SERVICE BULLETIN

#0005 Revision 1

SUBJECT: Incorrect material used on guides which could lead to premature wear on

MODELS AFFECTED: All Sling LSA, Sling 2, Sling Taildragger, Sling 4 - Manufactured after

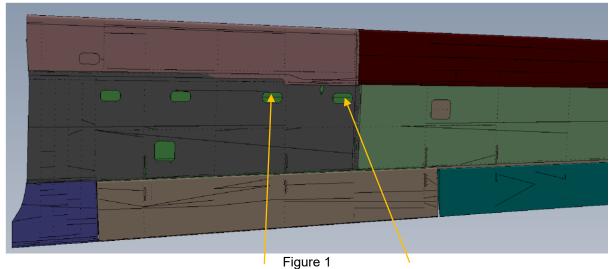
If any of the incorrect materials listed below are installed, or do not conform to the specifications listed, this service bulletin will apply.

Thickness	Colour	Material
Correct	3mm	Natural (Milky)	Polypropylene
Incorrect	Any	Clear	Other

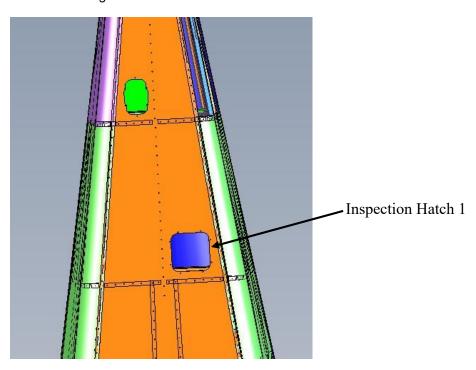
With reference to the above picture, inspection hatch 1 will need to be opened. This hatch is located on the bottom of the rear fuselage.

- 1. Unscrew all 8 screws and remove the hatch from the fuselage skin so as to gain access to the Pushrod located on the beam.
- 2. Visually inspect the pushrod for excessive wear. Visually inspect the pushrod guide for the correct material. The below pictures show the guide to be inspected.
